IN THE MATTER In the Matter of an application by Bryan
and Kim Roach & South Taranaki
Trustees Limited for construction of a
new dwelling and associated fencing
and retaining walls (retrospective) at
24/26 Woolcombe Terrace, New
Plymouth

STATEMENT OF EVIDENCE OF Emma McRae

NZILA Registered | Principal Landscape Architect

19 March 2025

Figure 3: Boon shading diagram 22nd Sept 4pm and actual view of 28 Woolcombe Terrace, 22nd Sept 4pm

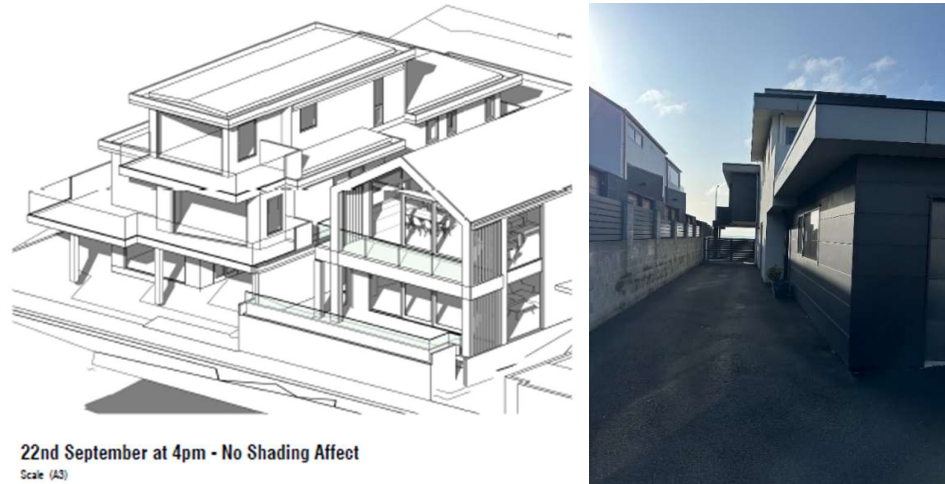
- 8.5 In that regard, I note there will be additional shading to the façade of 28 Woolcombe Terrace as a result of the HIRB breach. A comparison below illustrates the modelled time of 22nd September at 4pm which states “no shading effect” to the front balcony is presented alongside a photograph taken from 28 Woolcombe Terrace which does demonstrate shading to the lower side of the building from the rear HIRB envelope exceedance.

- 8.6 Further shading effects to the building façade/windows and the rear yard form part of my consideration in determining the overall level of effects associated with the infringements. In particular, and in reliance upon discussions with Mr Whyte, I understand that the rear yard is used by the submitter as an outdoor entertainment area on occasions, particularly when their primary outdoor living spaces to the front of the property are unsuitable due to the prevailing north/northwesterly coastal winds at the property. I also understand that the area is used by the submitters’ grandchildren to ride bikes etc. I understand that Mr Whyte will say that as he and his wife retire, they will look to make greater use of the rear part of this property for outdoor living, particularly when the northern façade is unavailable.

- 8.7 However, and having reviewed the applicant’s shading analysis, I confirm that given the levels of additional shading over this area compared with a compliant 11m high building, I agree with Mr McEwan and Mr Bain for the applicant that the effects of any additional shading on this area are considered to be low adverse. Effects of shading on the building façade are also low adverse, given the level of shading that could be achieved by a fully compliant 11m high building.

Figure 4: Excerpt from Boon drawing SK3.0 illustrating breach of 45 degree recession plane along first 20m of dwelling, and illustrated proposed exterior louvers to provide screening.

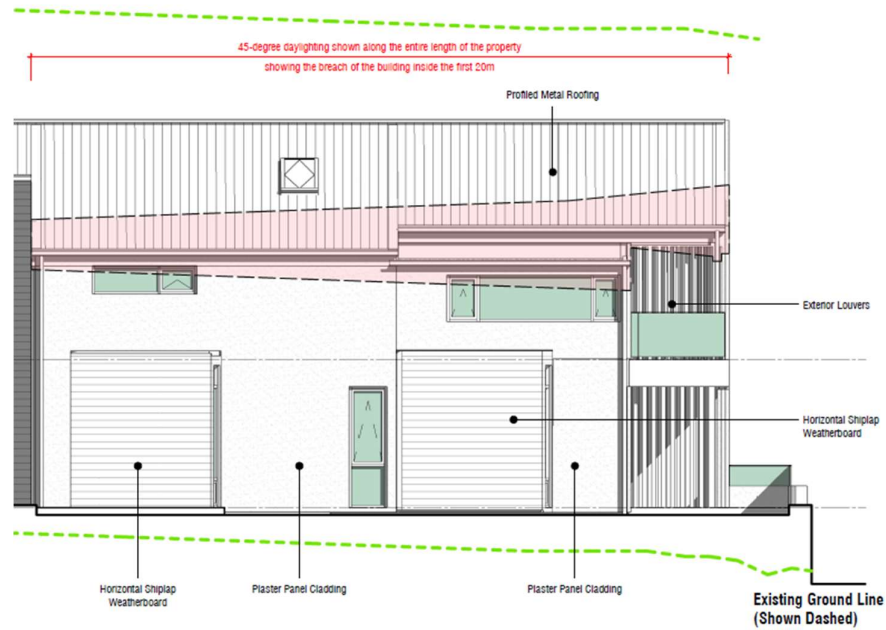
- 8.8 In relation to privacy, the Boon drawings illustrate the presence of louvres along the eastern elevation (see **Figure 4**). The s95 report describes that the louvres “effectively avoids any overlooking or privacy loss from this aspect of the infringement.” However, these louvres were not present on the as-built dwelling during the site visit on 26th February 2024, as illustrated below in **Figure 5**.

- 8.9 There is also overlooking from large windows present in the eastern façade in the centre of the building towards the Whytes’ property. The eastern deck area at 26 Woolcombe Terrace also diminishes the sense of privacy and overlooking, as it directly views 7 windows of the neighbouring 28 Woolcombe Terrace’s habitable rooms. Finally, the rear upstairs deck of 26 Woolcombe Terrace also provides overlooking to the rear section of 28 Woolcombe Terrace.

- 8.10 Without mitigation, my expert opinion is that the proposed building gives rise to privacy and overlooking effects along almost the entire length of the building, from front to rear. I conclude that effects in relation to privacy and overlooking are **low-moderate adverse**. I return later in my evidence to potential options to mitigate this effect.

Figure 8: Inset View of elevation of Boon drawing SK3 illustrating location of 2m high breach in elevation marked in blue.

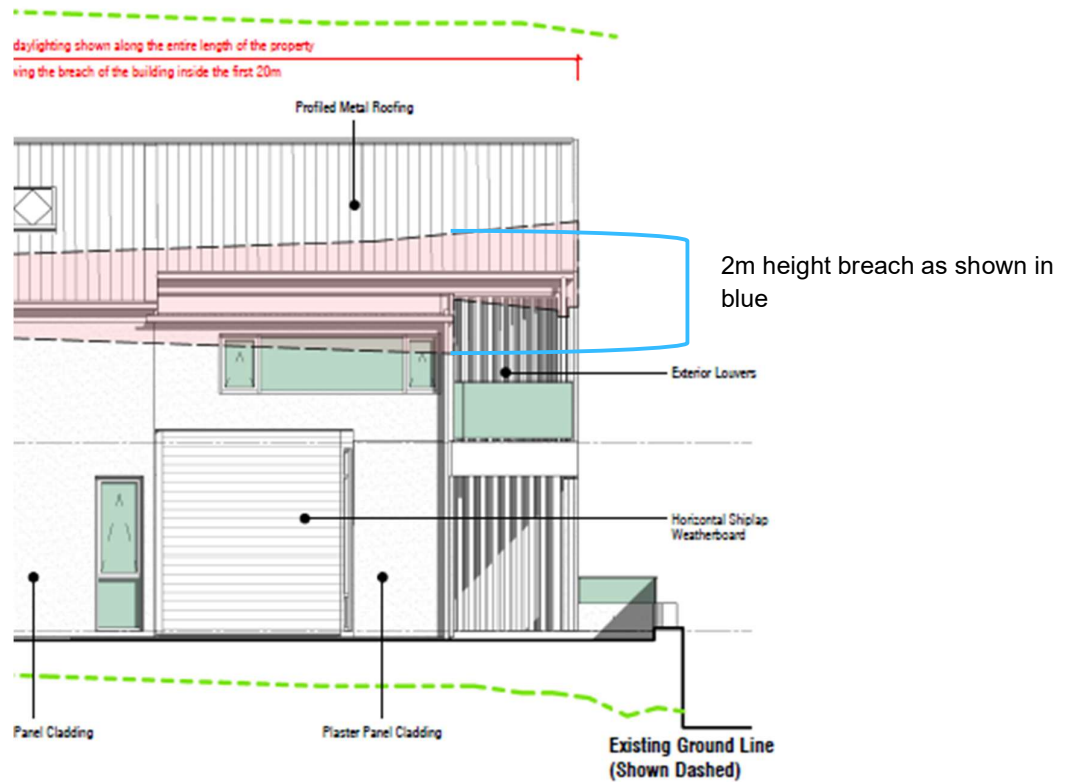
- 13.9 I agree with Mr McEwen that the breach does not extend the entire length of the building, with no breach occurring in the middle. I measure the total length of the breach to be 22.5m. In relation to the “height” of the breach, this depends upon how one is measuring this. Boon drawings SK.1 and SK3 provide plan and elevation views of the breach with the areas of the breach highlighted in red. The latest version of Boon SK1 (dated 6/08/2024) does not show the full extent of the breach in relation to Standard S3, this is only shown in elevation.

- 13.10 An earlier version of this drawing (20/9/2024, also illustrated on Mr McEwen’s Appendix B Sheet 1 and the s42A report on Page 7) does illustrate the full breach in relation to MRZ-S3. Measuring the greatest height of the breach along the façade in the elevation drawing SK3, this measures 2m, as highlighted in **Figure 8** below. This is the widest point of the breach in elevation, and it is not dimensioned on the elevation. Measuring this breach in plan view off Boon drawing SK1, it measures 2m in depth, see **Figure 9**.

Figure 9: Inset View of Boon drawing SK1 illustrating "depth" of breach at 2m width marked in blue. Boon drawing label notes "extent of infringement at 1500mm, but is measuring infringement at only the front of the building edge, not the greatest depth of the breach."

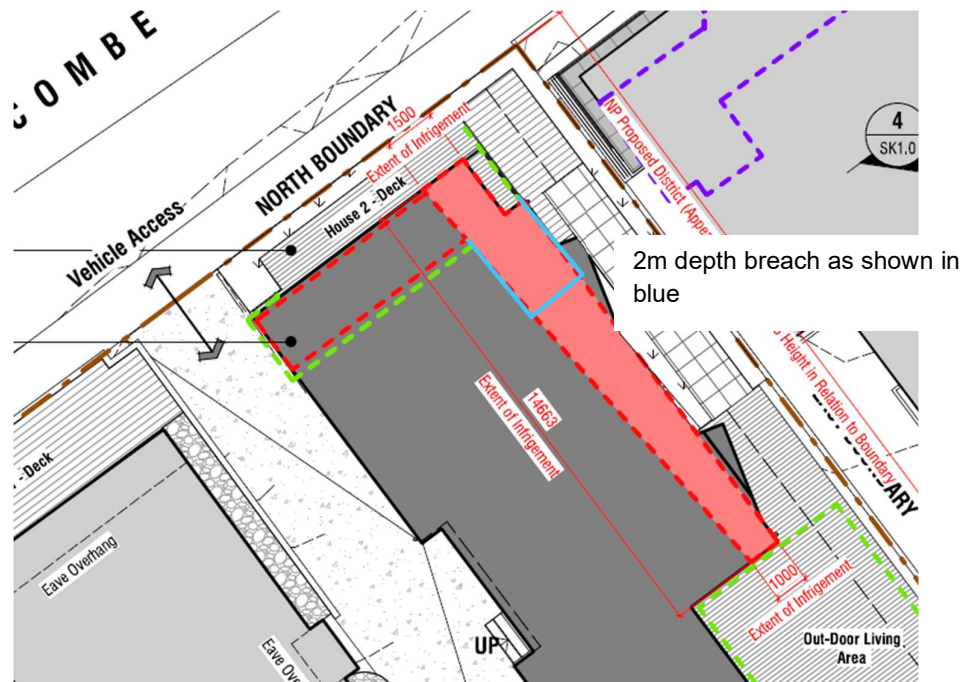
- 13.11 I note that the Boon drawing SK1 label notes the “extent of infringement” at 1500mm, but this is measuring infringement at only the front of the building edge, not at the greatest depth of the breach. The accompanying cross sections on Boon drawing SK1 demonstrate the dimension of the breach at 688mm depth (at the rear end of the building), and 1505mm depth (at the northern end of the rear section of the building). Mr McEwan’s evidence underplays the extent of this breach by not illustrating it at its greatest depth or height.

Figure 10: Front elevation of 26 Woolcombe Terrace showing MRZ S3 HIRB envelope in yellow, and the same building design moved to fit within the envelope. This places the outer front wall approximately 1.5m further away from the neighbouring 28 Woolcombe Terrace.

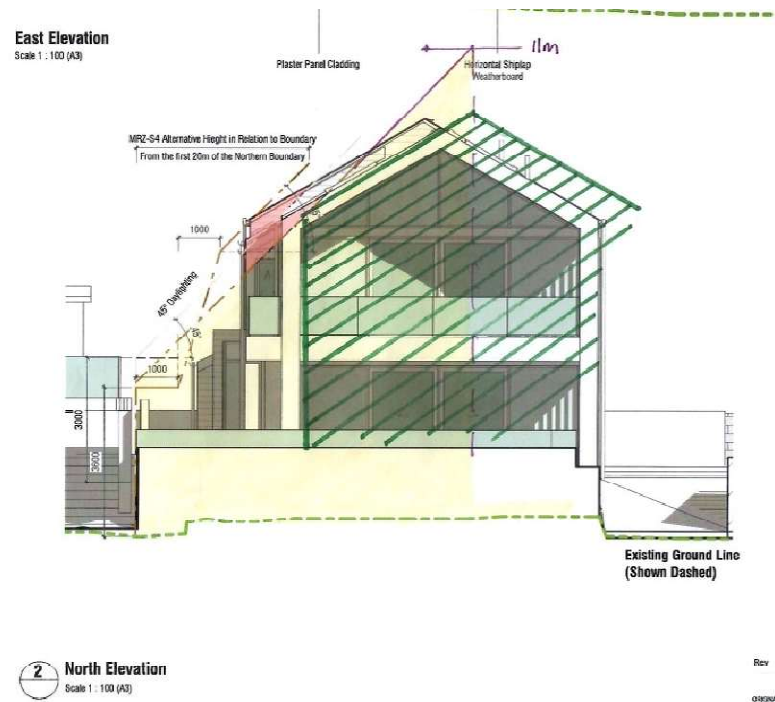
13.19 I do not agree with this statement. As per my analysis above, the length (22.5m), depth (2m) and height (2m) of the breach constitute a low-moderate adverse effect on sense of enclosure, above and beyond what a permitted building would create. This is because in order to fit within the HIRB envelope a building of the same design would either need to be located substantially further back from the boundary within 26 Woolcombe Terrace to fit in the envelope, or be a building of a completely different design that had a lower roof angle or lower in height boundary walls which does not afford the same length and level of breach which contributes to the overbearing effect. **Figure 10** demonstrates the MRZ S3 HIRB envelope which a permitted building could occupy shaded in yellow. The green hatch indicates the offset a building of the same design would be required to fit in the envelope. This would set the eastern wall of the building around 1.5m further back from the shared boundary.

- 13.29 Again, I refer back to **Figure 10** as to what could be constructed with a complaint envelope, and an alternative envelope with further matters of discretion attached. As discussed above, I believe that a dwelling which complies with the permitted envelope, set back appropriately from the boundary, would result in reduced overbearing, overlooking and sense of enclosure effects when compared to the as-built dwelling. In addition, I note that a building which complies with the alternative HIRB standard is still required to appropriately address the additional matters of discretion in MRZ-R33, and to demonstrate that it is consistent with the relevant objectives and policies of the MRZ. It is my opinion that the as-built building does not appropriately address the matters of discretion for overlooking and privacy, as outlined above in Section 9, and that

- 15.4 Adverse effects of the development are potentially able to be avoided, remedied or mitigated through:
- Redesign of building's eastern facade further away from boundary so it does not exceed HIRB envelope

- Reduction in height/angle of roof plane so it does not exceed HIRB envelope
 - Installation of louvres/window tinting in appropriate locations to reduce overlooking/increase privacy
